May 17, 2013

**Linoma Software**  
**Building Renovation / Remodel Project**  
**ASHLAND, NEBRASKA**

#### **ADDENDUM #1**

**Sheet A3.1**

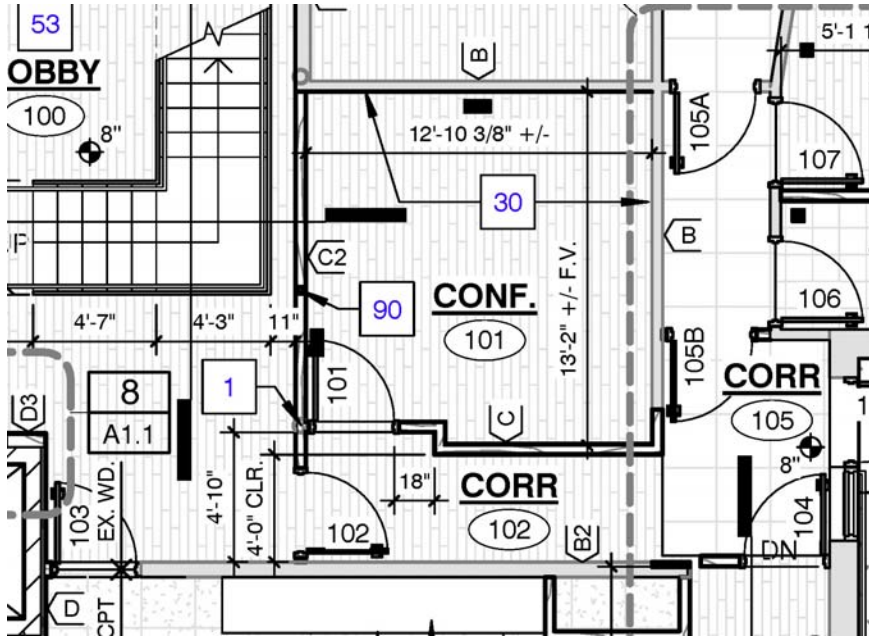
- A. Refer to Reflected Ceiling Legend. 2x2 ceiling pads to be CertainTeed Sand Micro with a standard reveal edge or equal.

**ATTACHMENT #1**

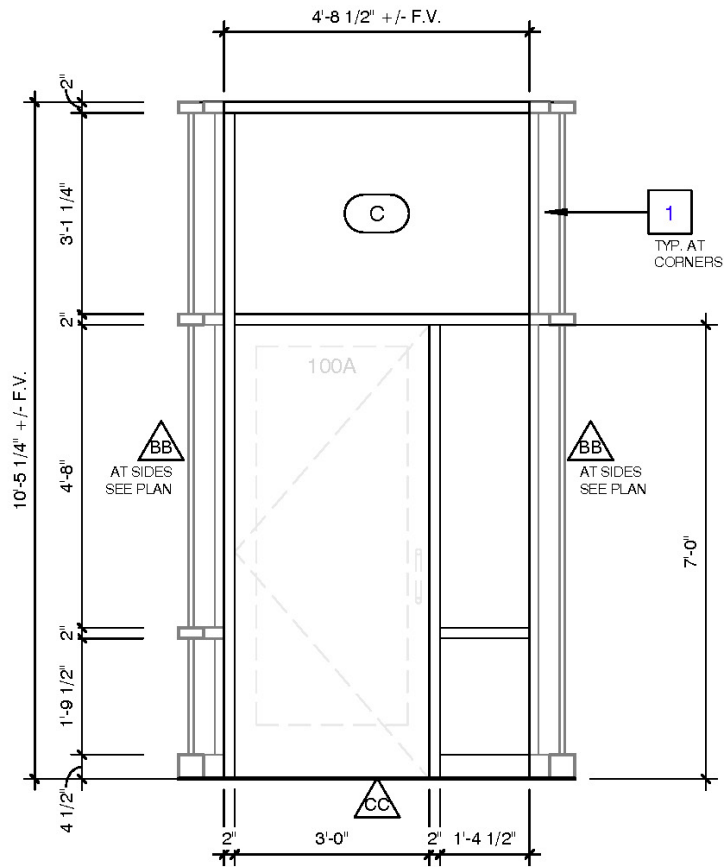
- D. Refer to First Floor Plan. Relocate door 102 from East end of Corr 102 to the West end of Corr 102 and provide a “jog” in the wall of the Conference room to allow for required accessibility clearances. See Attachment #1.
